RE: TRAMWAY BLVD. EXTENSION SOUTH OF CENTRAL AND WENONAH, PROJECT NO. 3340

TO: Suzanne Dougharty, Engineering PWD/Transportation Div.
FROM: Loren D. Mainz, Hydrology Division *LDM*
SUBJECT: Project No. 3340 L22/D48
Drainage Report for Tramway Blvd. Extension,
Central to Wenonah, and Wenonah to Four Hills Rd.

REVIEW OF PLANS FOR
 TRAMWAY BLVD. EXT. SO. OF CENTRAL
 &
 WENONAH AVE E. OF TRAMWAY.

TRAMWAY BLVD. EXTENSION SOUTH
OF CENTRAL AVENUE S.E. AND
WENONAH ROAD

SHEET 7

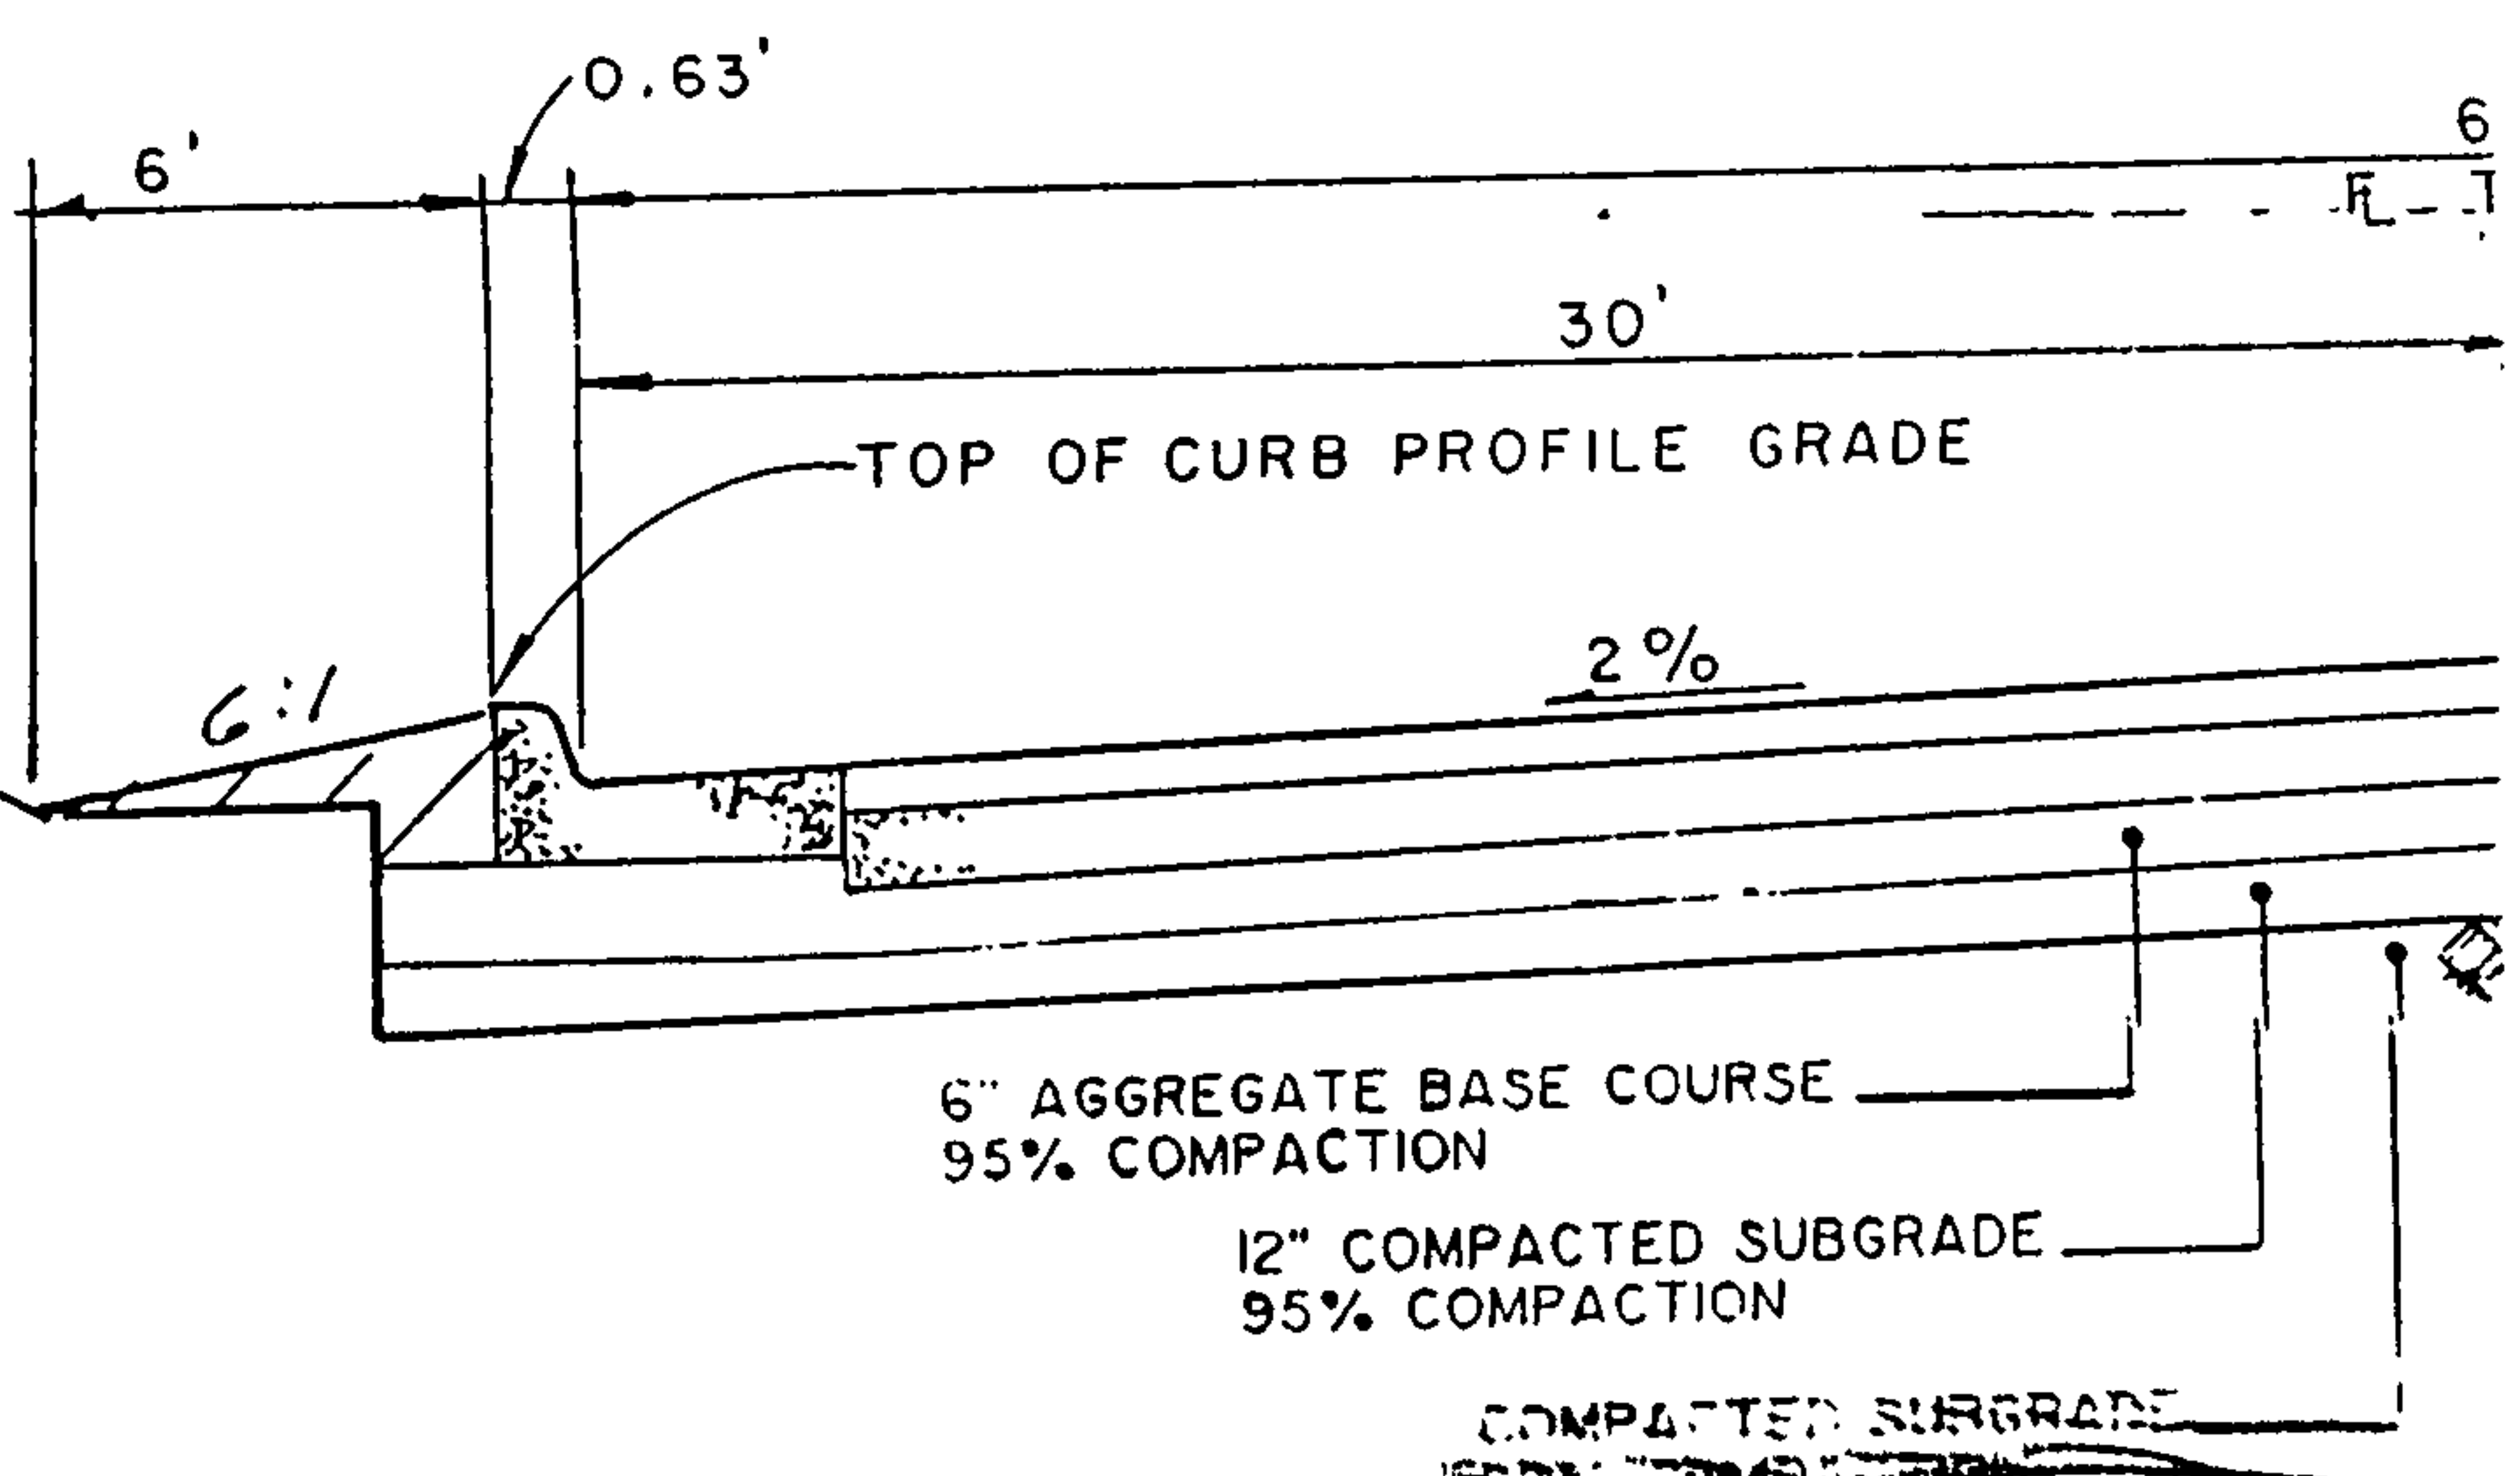
- comments sent to Suzanne Daugherty.
- Discussed additional plan modifications with comm. consultant.
- Red lined plan set given to consultant with instructions to return the plan set to Hydrology Division.

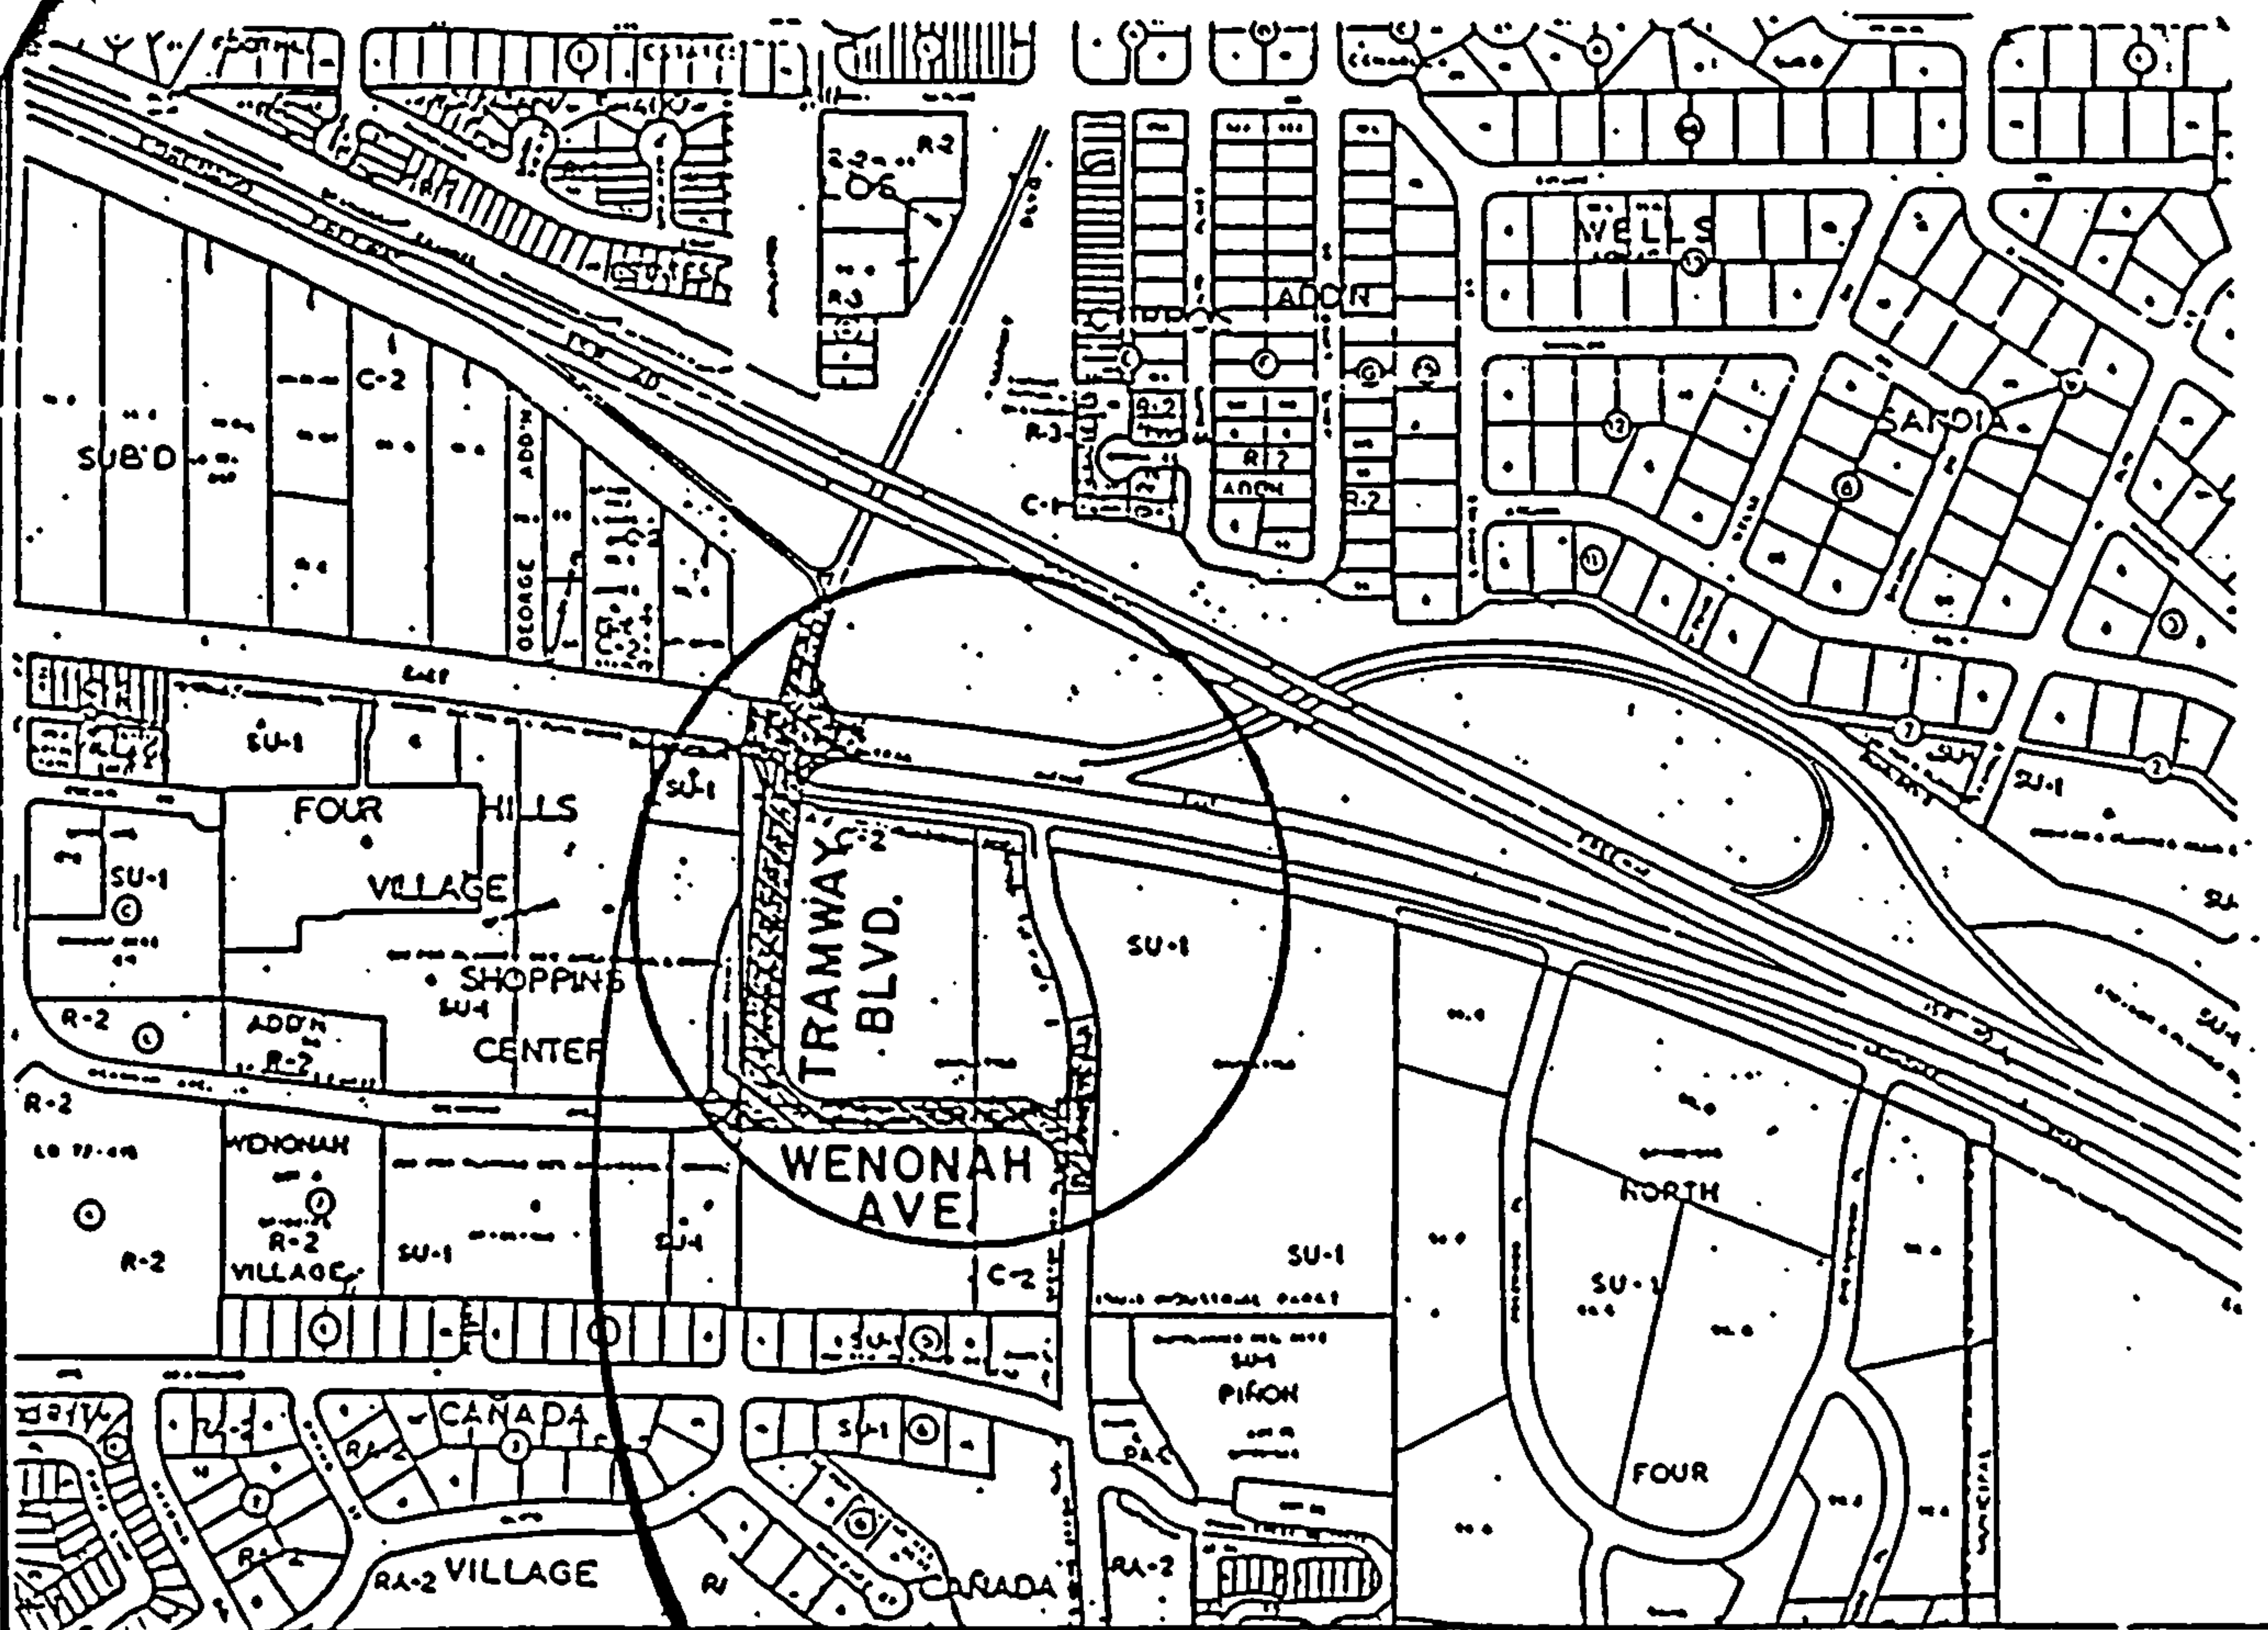
4) PROFILE GRADE SHOWN IN CALC'S (P. 10) FOR TRAMWAY IS $S = 0.83\%$. CONTOURS INDICATE AN OVERALL SLOPE OF APPROX. 2.5% . REPORT SHOULD INCLUDE APPROX. STREET PROFILES TO VERIFY CALCULATIONS.

6) REPORT INDICATES MIN. PIPE SIZE OF 24" (P. 1), ~~■~~ BUT PLAN SHOWS SEVERAL 18" PIPES. VERIFY & CORRECT.

8) TRANSPORTATION PLANNING, COA,
SHOULD REVIEW GEOMETRY AND
ACCESS FOR PROJECT.

PLATE 22.3, D-5

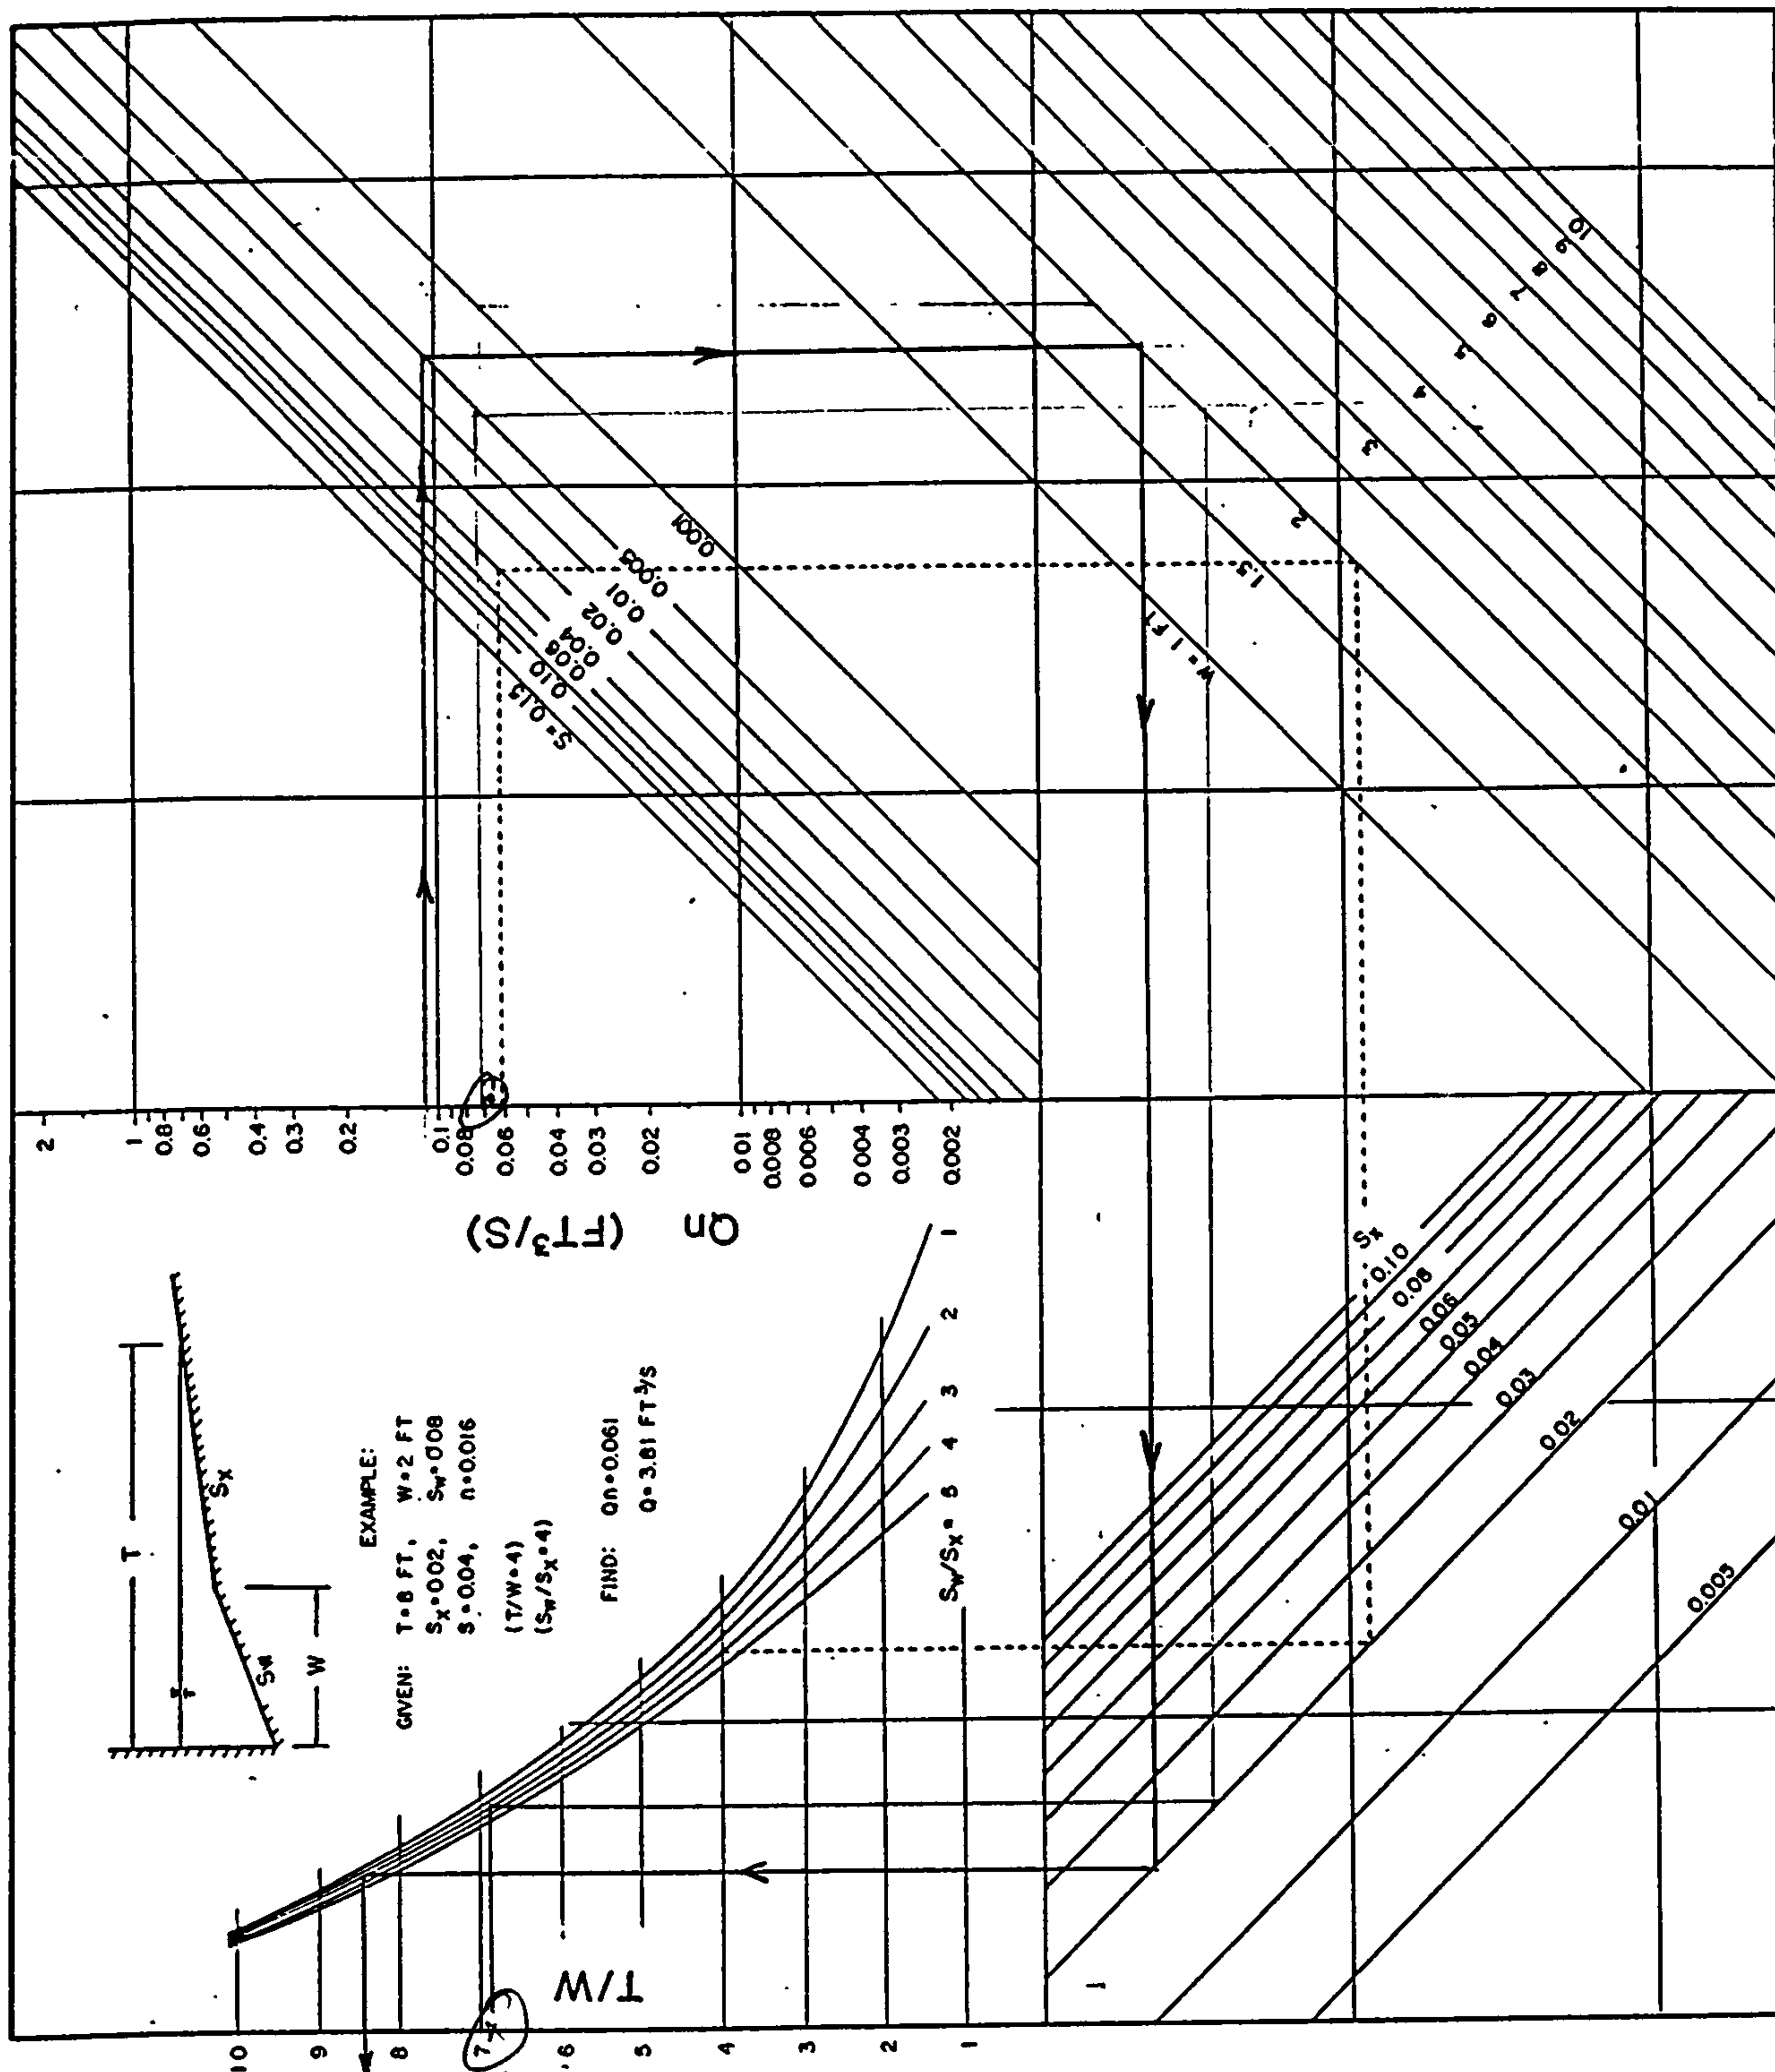
correct design-
ation?
will S. side drain to
east or to west?
